REPORT AND ACCOMPANYING PLANS FOR THE VAFFC DEVELOPMENT PERMIT AT 15040 WILLIAMS RD. (DP 16-741741)

To:	David Weber Director, City Clerk's Office	**Date:**	July 9, 2019
From:	Wayne Craig Director, Development	**File:**	DP 16-741741
Re:	**Application by – Vancouver Airport Fuel Facilities Corporation (VAFFC) for Development Permit at 15040 Williams Road**

2. Development Permit 16-741741

Permit the construction of a Marine Terminal Facility for aviation/jet fuel delivery at 15040 Williams Road on a site zoned "Industrial (I)" and partially designated as an Environmentally Sensitive Area (ESA).

1 Northeast Shoreline ESA Areas

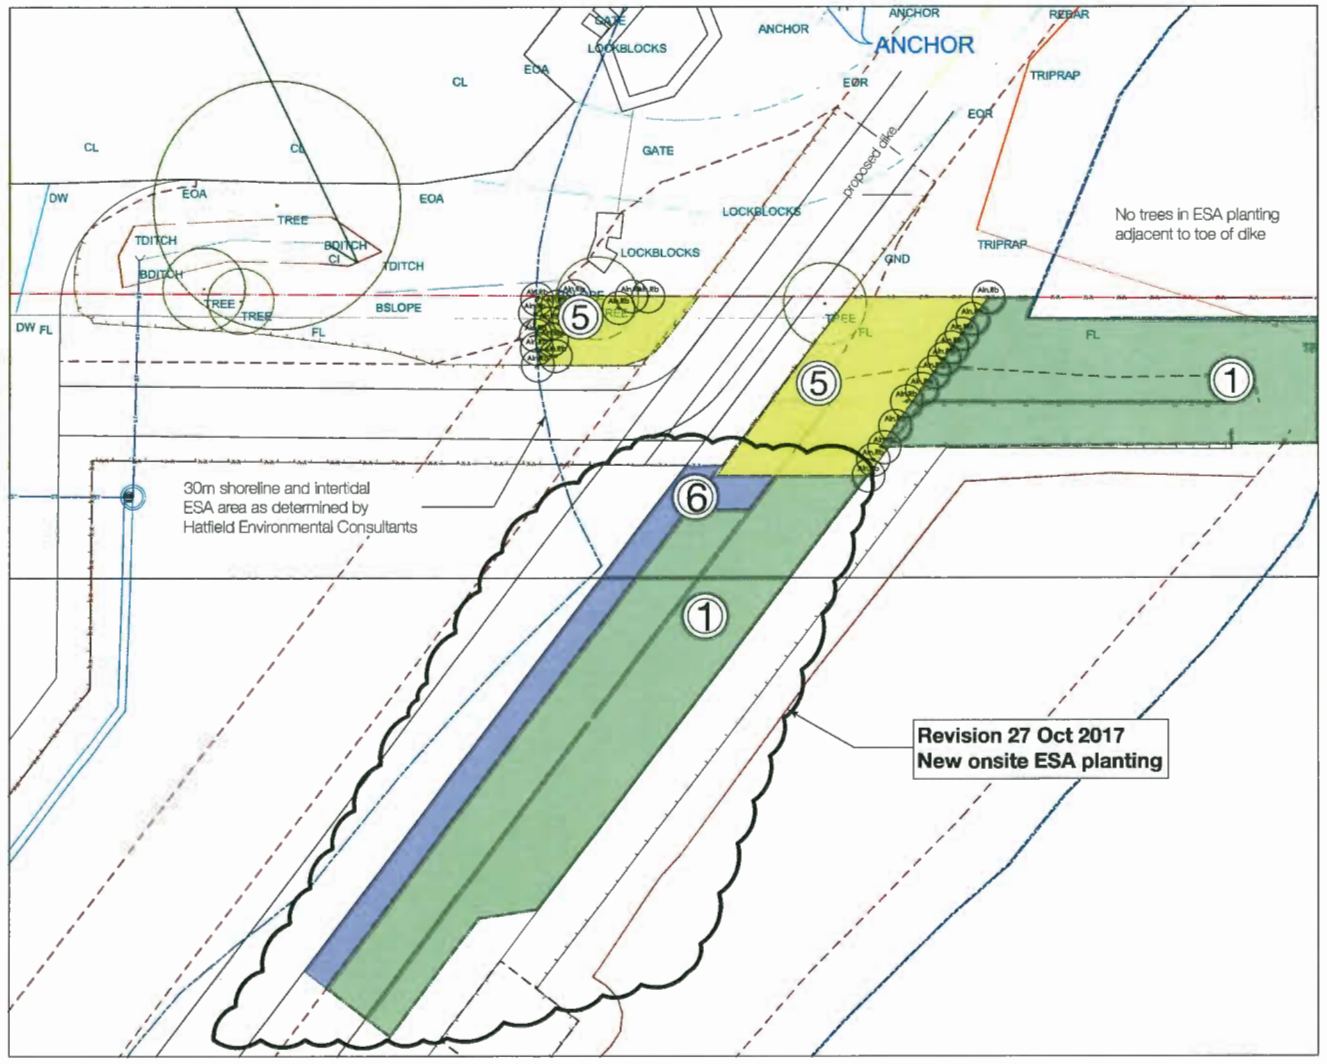
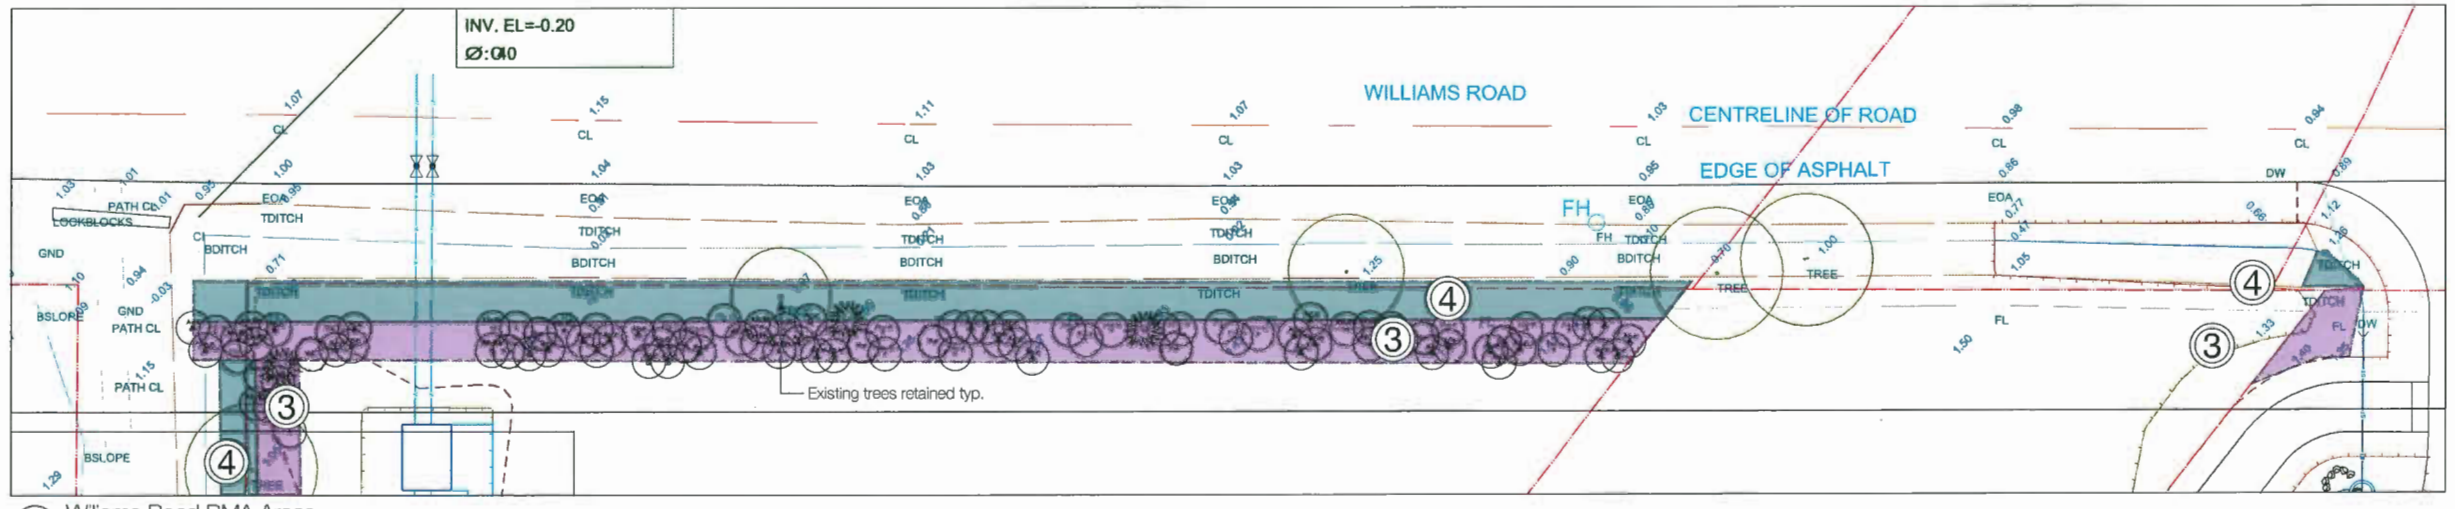
(a) review the proposed mitigation, compensation and enhancement scheme for shoreline ESA based primarily on existing ESA condition in the subject site and investigate opportunities for additional on-site ESA planting;

(b) review the proposed compensation/enhancement planting scheme for the shoreline ESA and consider introducing more mature and substantive planting;

- an additional 702 square meters of planting will be introduced at the northeast and southwest portion of the site's Environmentally Sensitive Area (ESA);

- the proposed additional ESA planting will increase on-site ESA planting by more than 200 percent (bringing the total on-site ESA planting area to more than 1,000 square meters), and increase the compensation-loss ratio to over five to one;

- approximately 60 trees and 2,500 shrubs will be added to the on-site ESA and Riparian Management Area (RMA) planting scheme, with the pot sizes of coniferous trees to be increased;

Drawing
TRIANGLE SITE PLANTING AREA

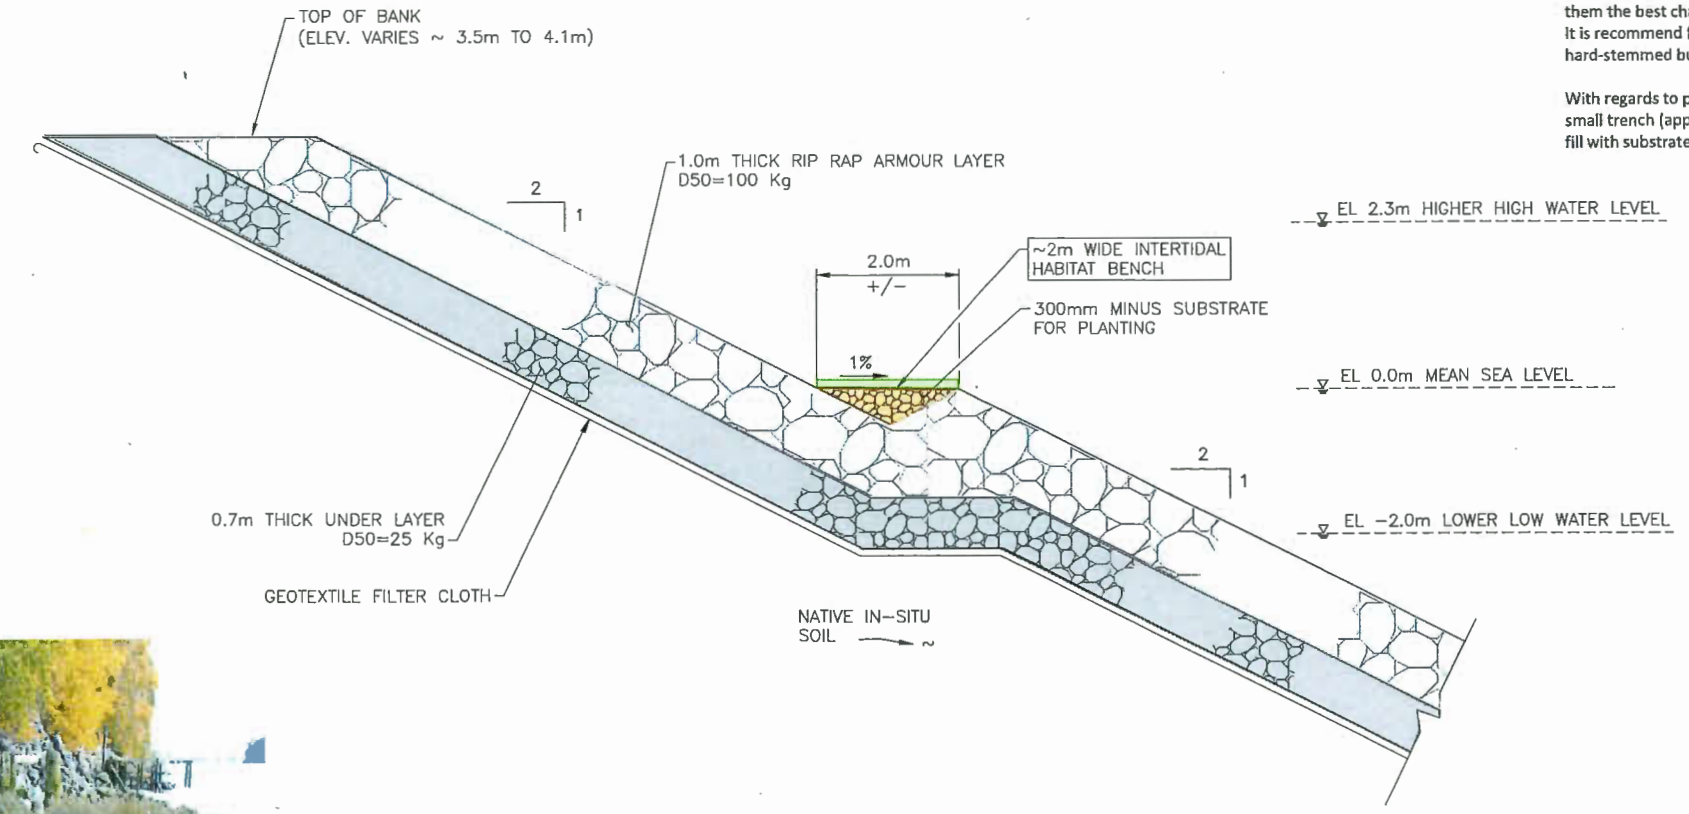
- 645 square meters of additional on-site non-ESA and non-RMA planting is proposed at a new trailside area in the northeast corner of the site and new three-meter wide planting strip adjacent to Williams Road RMA; there is also a 1.5-meter widening of one side of the proposed planting strip adjacent to the public trail;

- total on-site non-ESA and non-RMA planting area proposed to be added is approximately 1,300 square meters, increasing significantly the overall on-site planting compared to the original proposal;
